KETCHIKAN, ALASKA
WATER STREET

REHABILITATION / REPLACEMENT OF OFF SYSTEM CITY BRIDGES
PROJECT NO BR-000S(735)~69534
68738 WATER STREET TRESTLE #2 REPLACEMENT - REIMBURSABLE

AS-BUILT SET

1 / E09 SUSPENDED WATER SERVICE DETAIL – SERVICE TO PROJECT RIGHT

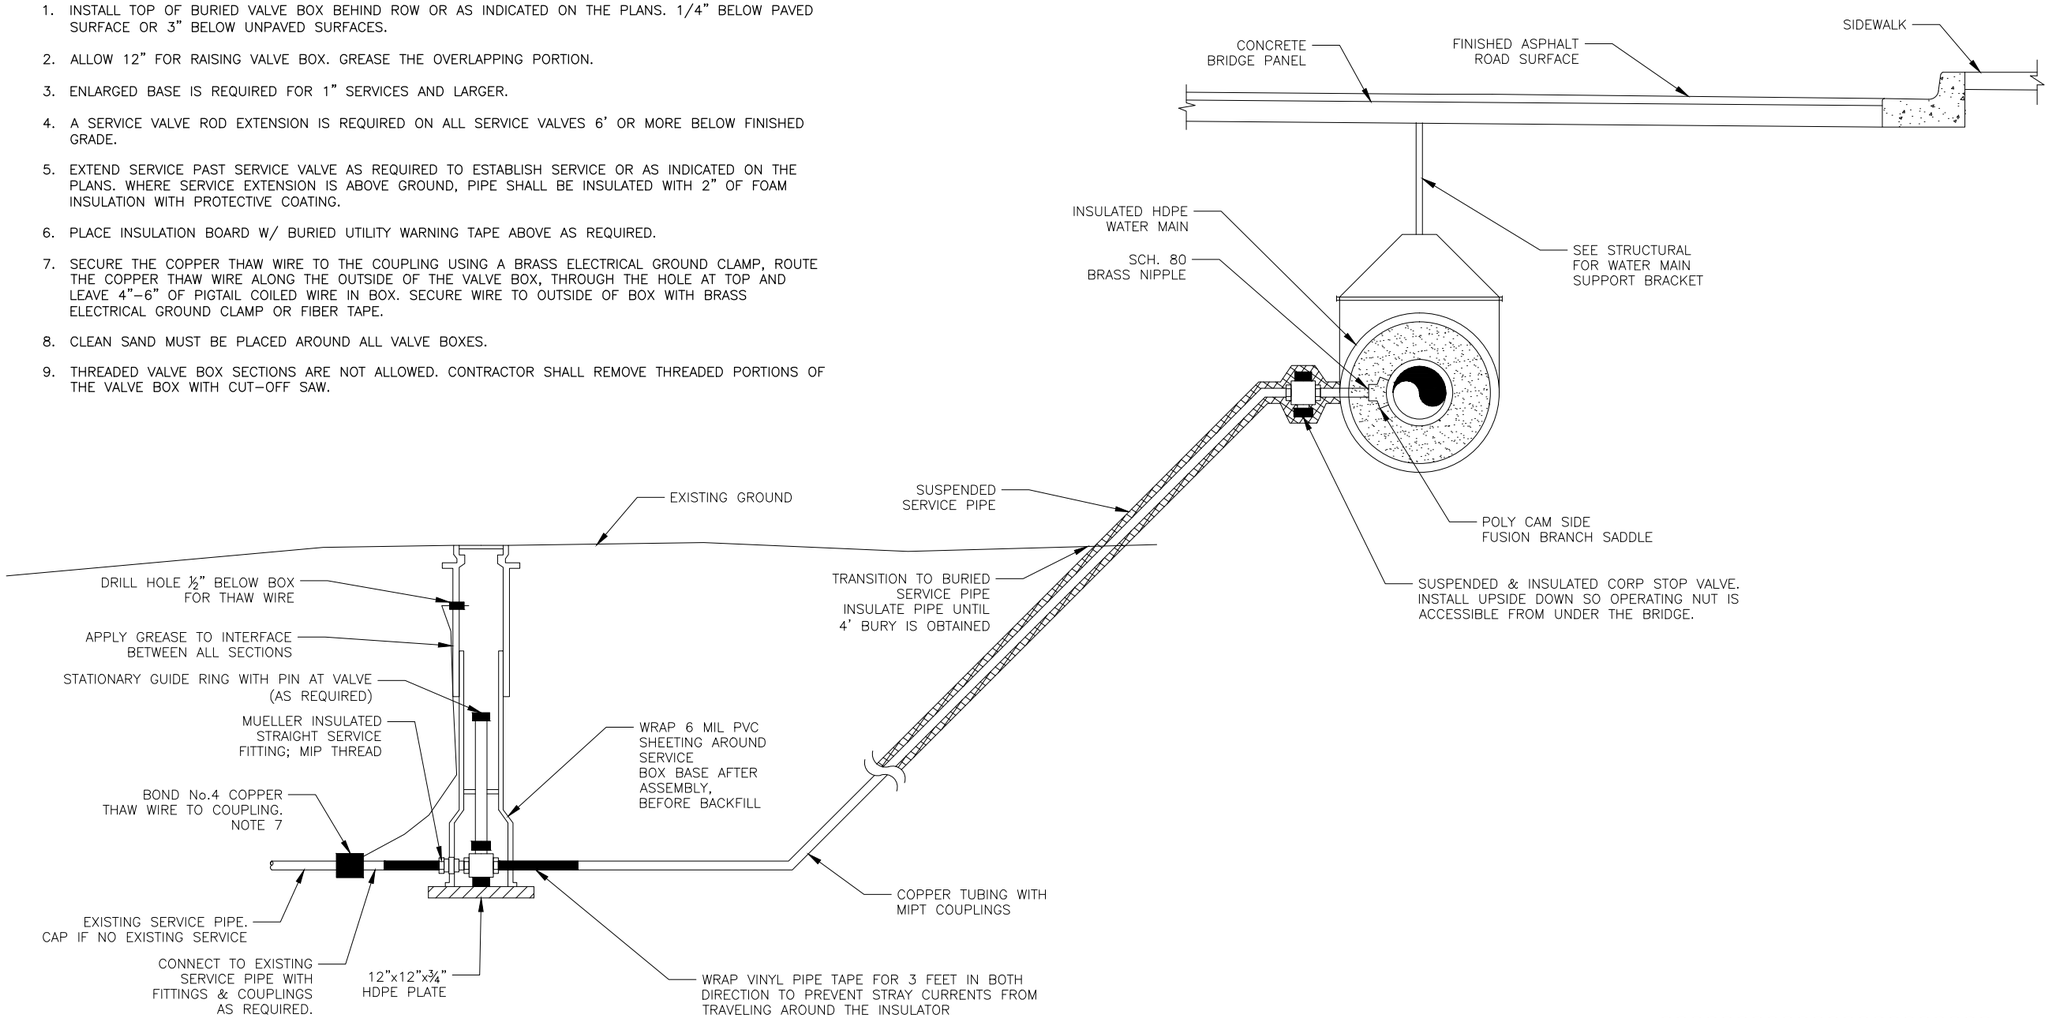
Change Order #25 and RFI#101 provide further details/clarification to this design, see next couple sheets E09A-E09B, and N94A.

WALL SHORING PLAN: ~~1442~~ 1446

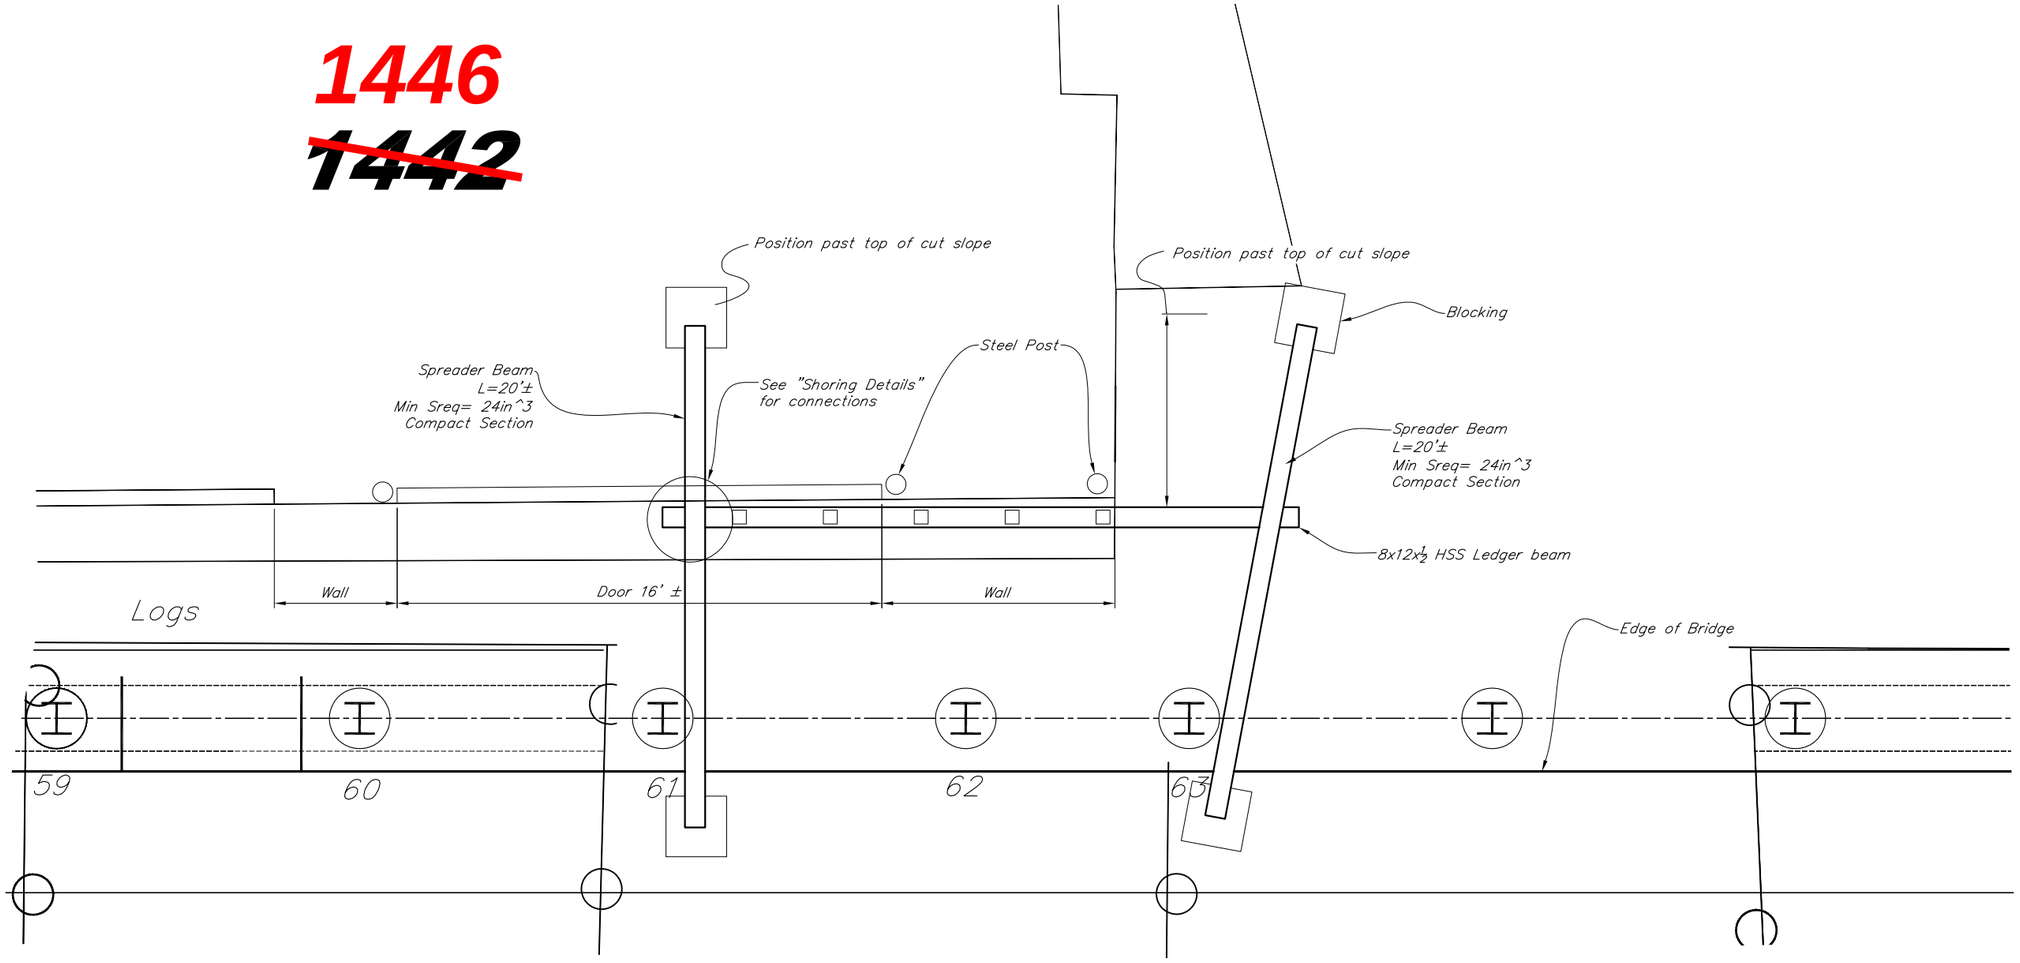
Temporary Bracing removed

RFI 218

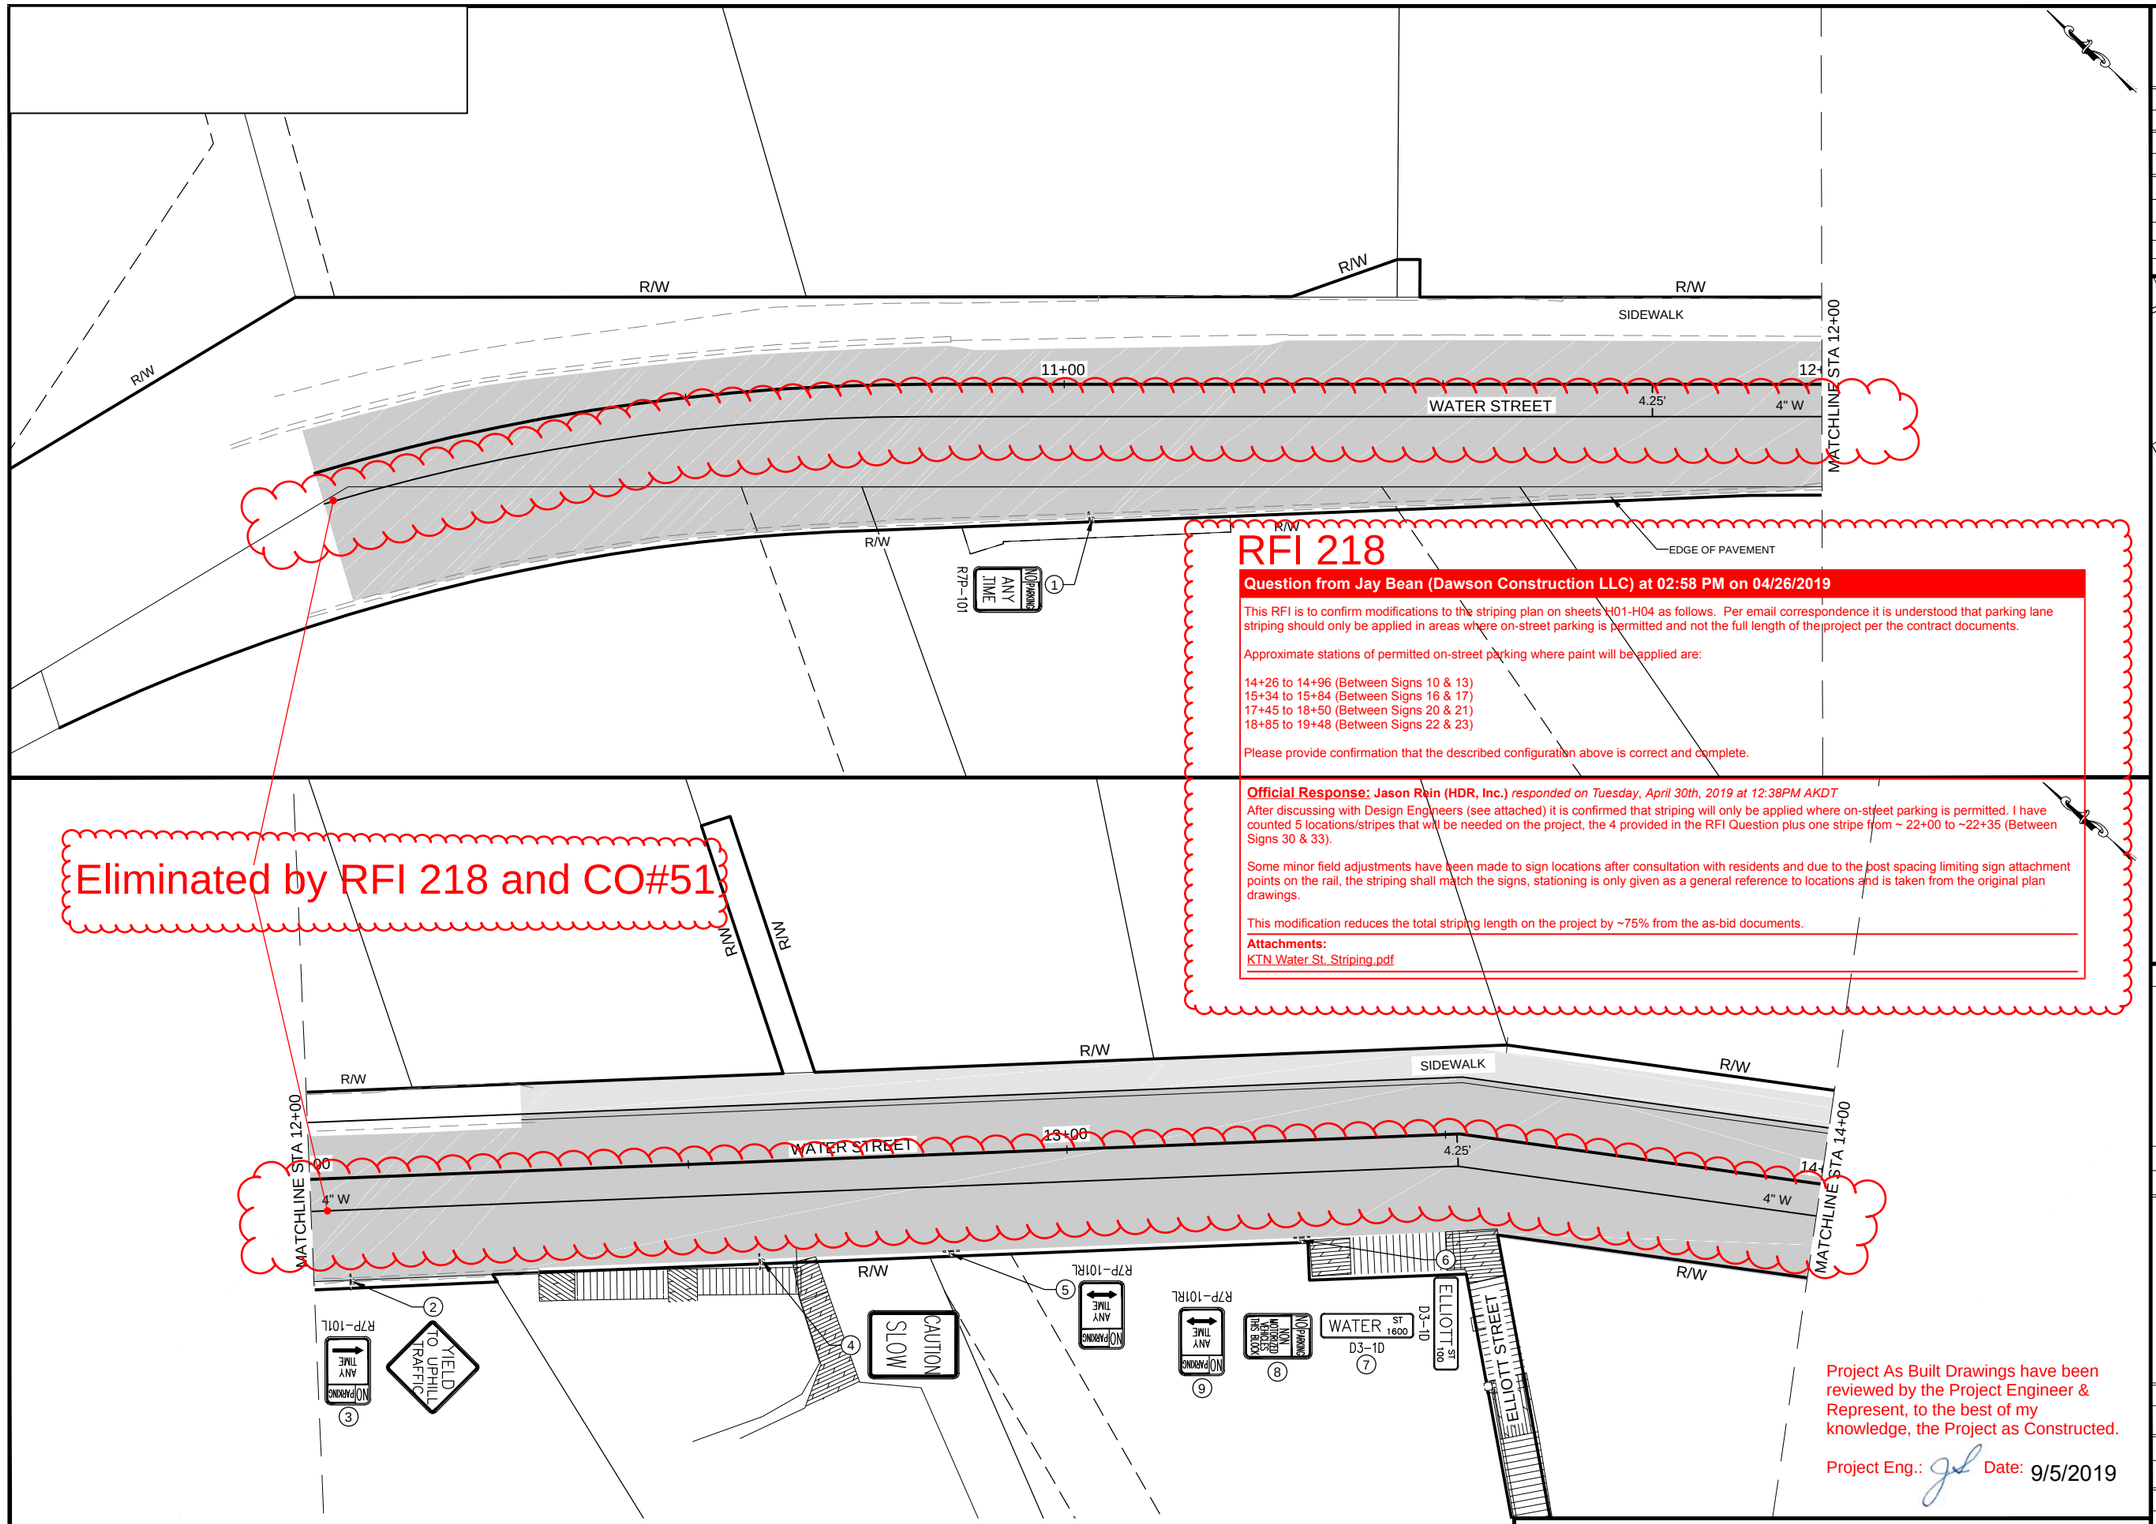
This RFI is to confirm modifications to the striping plan on sheets H01-H04 as follows. Per email correspondence it is understood that parking lane striping should only be applied in areas where on-street parking is permitted and not the full length of the project per the contract documents.

STATE	PROJECT DESIGNATION	YEAR	SHEET NO.	TOTAL SHEETS
ALASKA	BR-000S(735)	2015	N30	N110

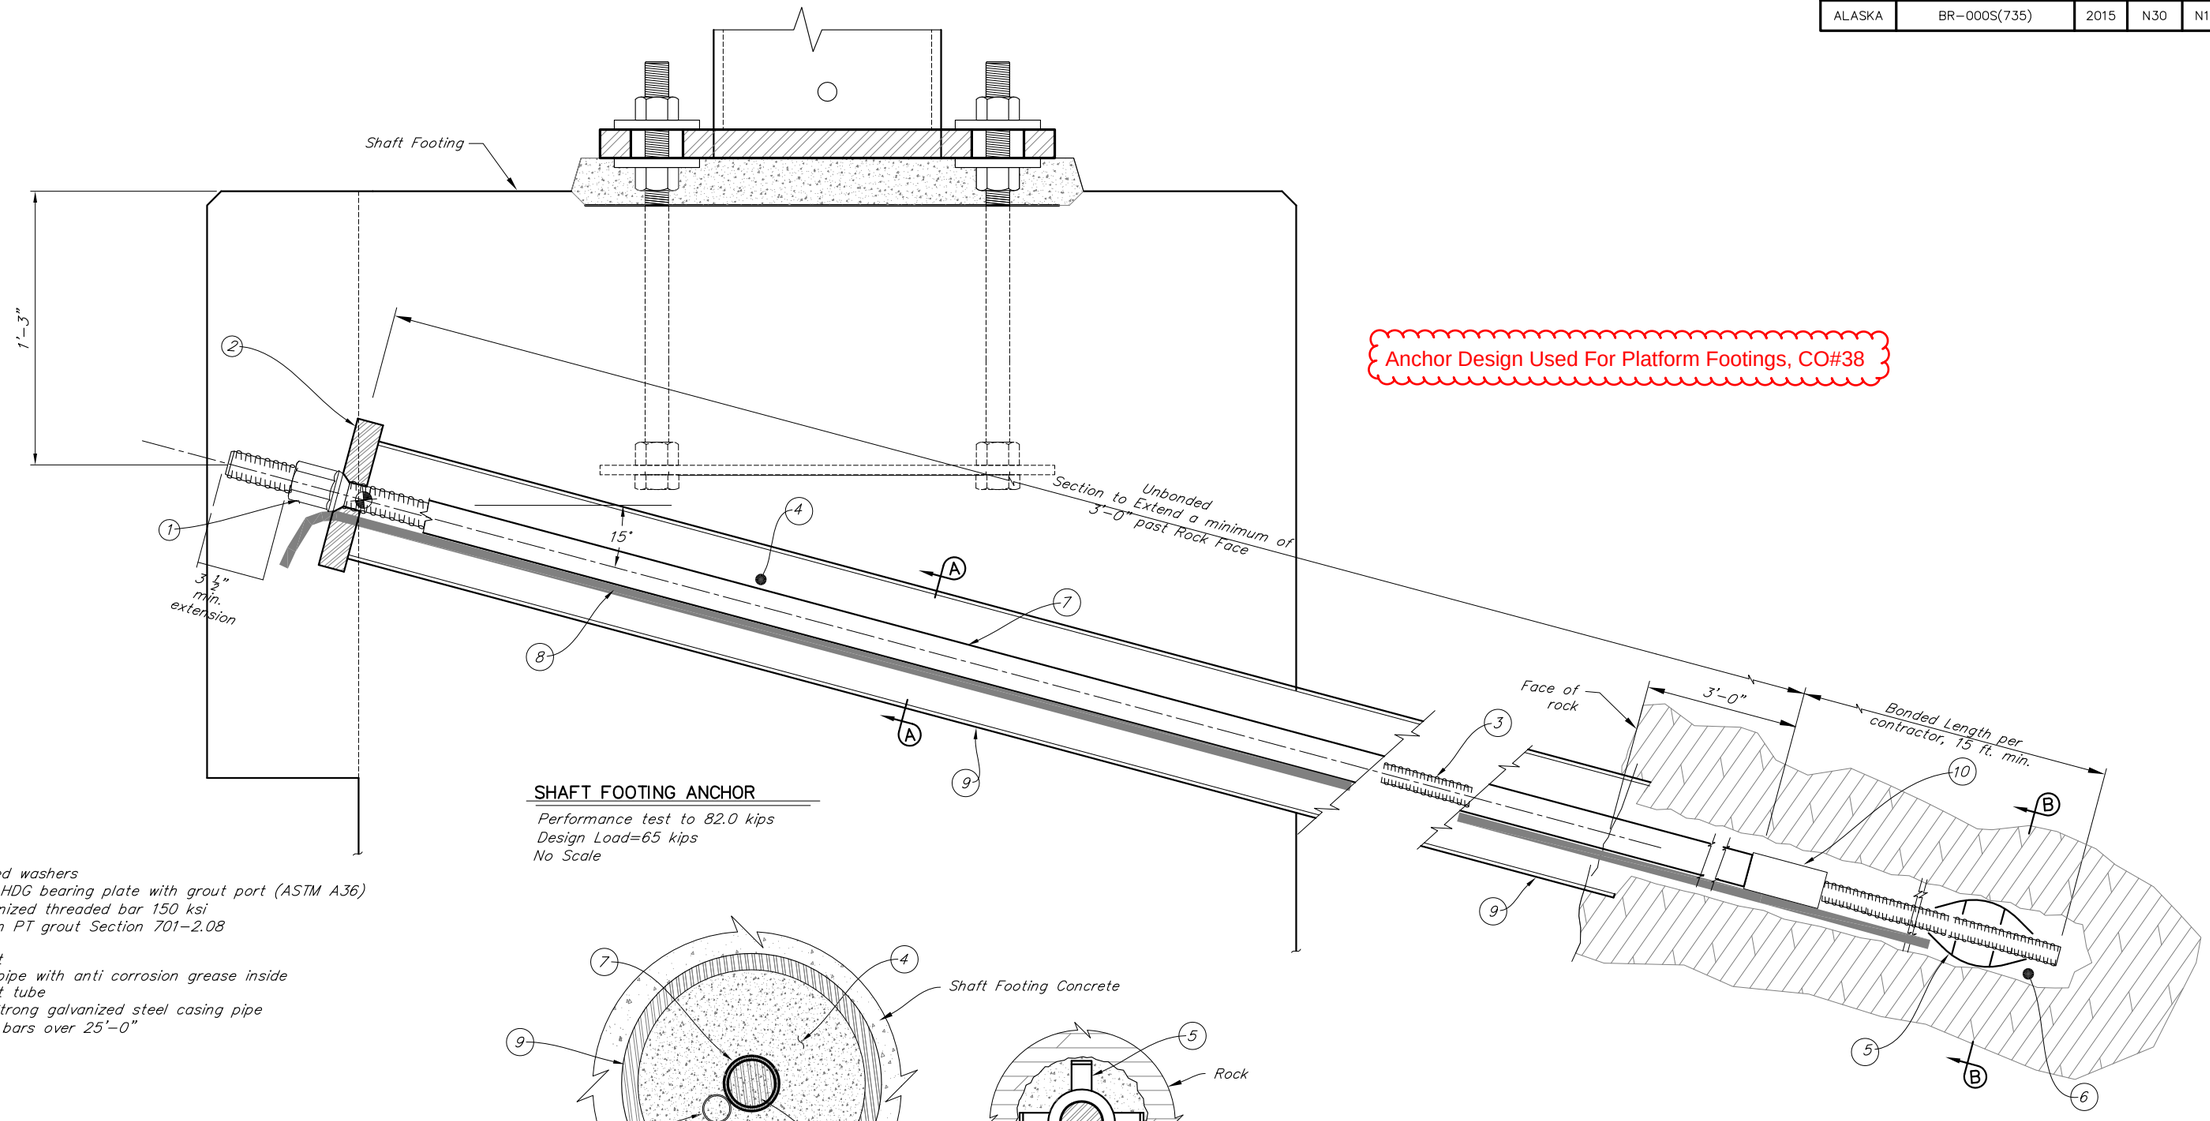
Anchor Design Used For Platform Footings, CO#38
